Service Bulletin

Bulletin No.: PIP6064

Subject: LZ0 Multiple DTCs Due to Melted Harness

6927354

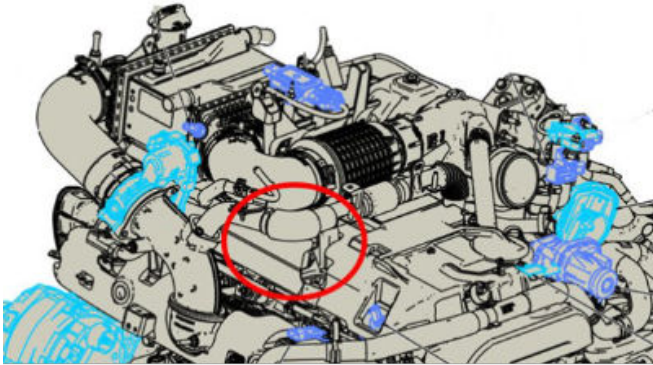
Involved Region or Country	North America
Condition	MIL on with any of the following DTCs set in the ECM: B2AEF, P00EA, P00EB, P00EC, P01BB, P01BC, P01BD, P0202, P0203, P0204, P0206, P0264, P0265, P0267, P0268, P0270, P0271, P0276, P0277, P0335, P0403, P0405, P0406, P045A, P045C, P045D, P0489, P0490, P0651, P0685, P0686, P0690, P0960, P0962, P103B, P103C, P1249, P124A, P124B, P124D, P1682, P16A7, P16B3, P16BC, P16BD, P17F5, P17F6, P17F7, P17FA, P17FB, P17FC, P2053, P2147, P2148, P2150, P2151, P2153, P2154, P2156, P2157, P216B, P216C, P217B, P217C, P217E, P217F, P2381, P2382, P2384, P2564, P2565, U1608, U1609, U160C, U1610, U1611, U1615, U1617, U1639, U163D, U1643, U1647, U1659, U165A, U1818 and/or P0641.
Cause	This may be caused by a damaged wire harness that has come into contact with the EGR cooler outlet pipe or the duct bracket.

If you have any of the above DTCs, check the harness for damaged in the area indicated in the picture below. Repair as necessary and secure the harness to prevent repeat damage.
